LIDCO, Pars SEE Zone, Assaluyeh,  
Integrated Methanol and Ammonia  
Plant 3000 MTPD MeOH / 900 MTPD NH3 PROJECT

Piping & Instrument Diagram

Document No. 17735-03

**PR-16:** P&ID for High Pressure Air Compressor K020

Integrated Methanol and Ammonia Plant				
5-03 P&ID				
P.O. No.				SC.
6019				SIZE: A3
DEPARTMENT	DOC. TYPE	SERIAL No.	REV.	SHEET No.
PR	PID	0002	01	1 OF 2

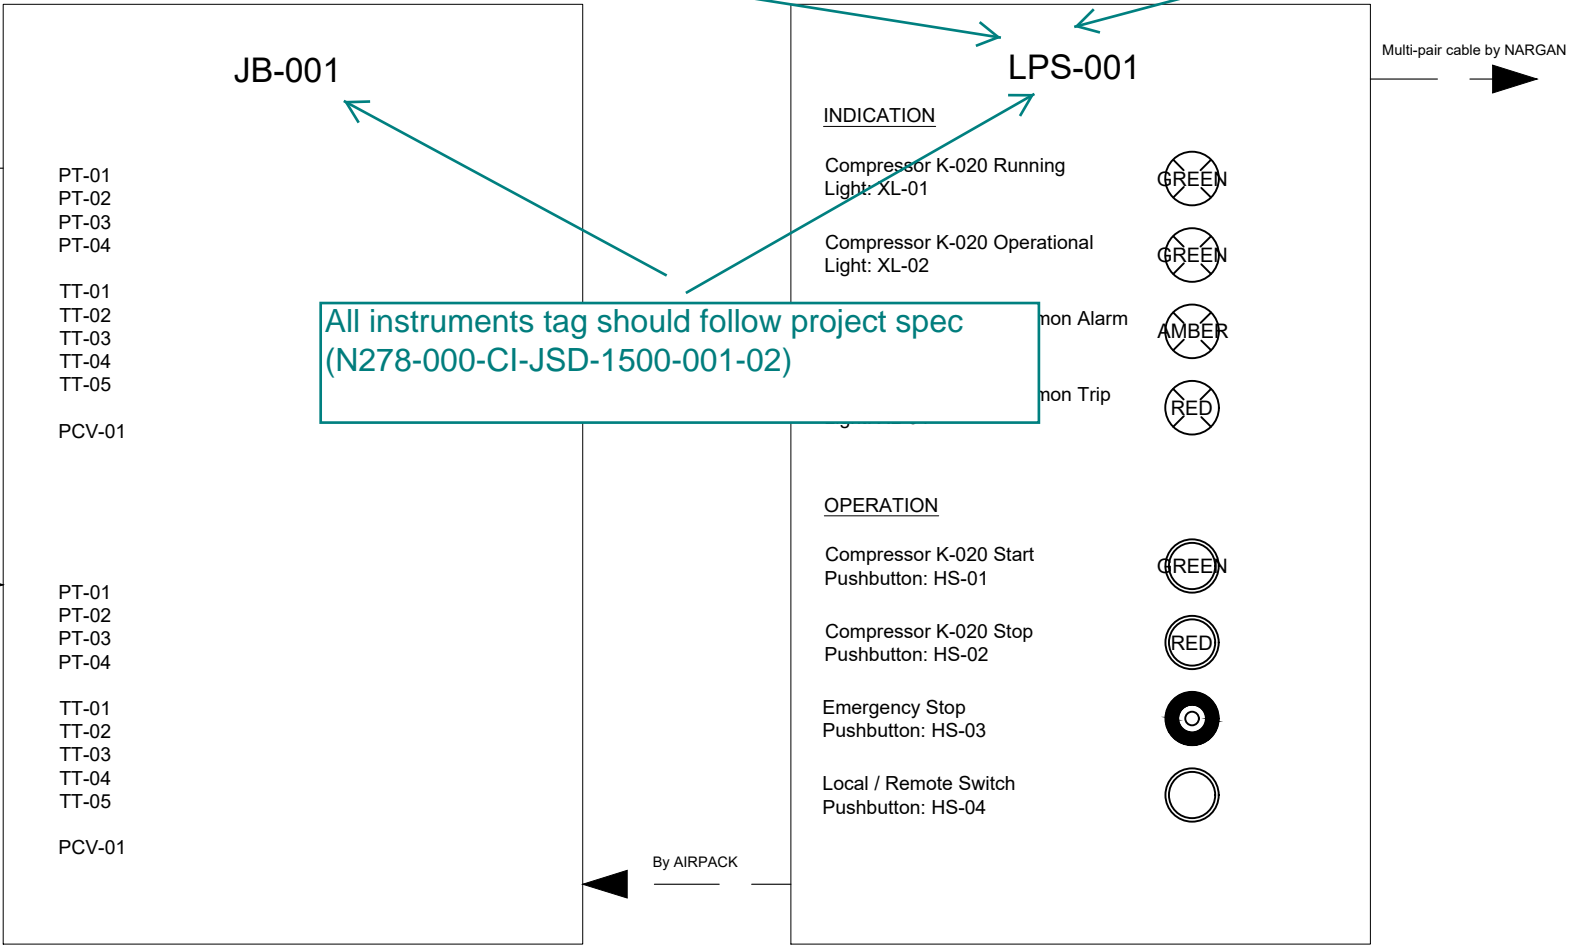
**PR-17:** DP of tube side also shall be specified.  
10/13 rule shall be considered or PSV shall be installed

**PR-19:** All design temperature shall be checked based on project sizing criteria:  
- Maximum operating temperature +15 °C  
- Design temperature shall be rounded up to full 5 °C steps.

**PR-4:** It conflicts with our tag numbers, to be corrected.

**PR-5:** OT: 46 °C  
DT: 75 °C

The inlet and outlet size of all PSVs to be specified.  
LO isolation Valve shall be considered for PSVs.

Is it shaft driven?(if motor drive, to be added in consumption list)

**PR-8:** Compressor shall not be started at the Low suction pressure. I.e. Permissive to start signal shall be generated from NOT low low condition of suction pressure.

please recheck the ratio of design pressure to operating pressure to ascertain that PSV does not act during normal operation (because of pressure pulsation in the discharge side of compressor).  
In other words, Design pressure of inter stage equipment, Instruments and piping shall be rechecked. Distance between design and normal pressure is lower than 10 %.

**PR-18:** Set = 75 °C

**PR-18:** Set = 75 °C

**PR-11:** Set point for PCV shall be specified  
**PR-12:** Positioner for control valve with related alarm in control room will be considered.

**PR-15:** Cooling rate shall be specified

**PR-9:** Size of all Lines shall be added in PID.

**PR-14:** TG and Globe valve shall be considered

**PR-13:** Outlet T shall be specified

All tags, Should be mentioned as per sample

Skids should be Considered or move here

All suffix tag should be start 82XX

comment for both coolers:  
Vent/drain with valve to be considered on both sides.  
MOM: vent/drain for water side and drain for gas side will be added

- Instrument comment:
- All instruments tag should follow project spec (N278-000-CI-JSD-1500-001-02)
  - Prefix "320" to be added to all instruments number.
  - **The Legend shall be considered (Consist of all instrument, equipment and line ...)**
  - all line size(Line No.) should be mentioned
  - All PSV and CV Sizes will be finalized after the approval Instrument calculation sheet document.
  - As per project specification, thermowells shall be installed at least on 6" line size.
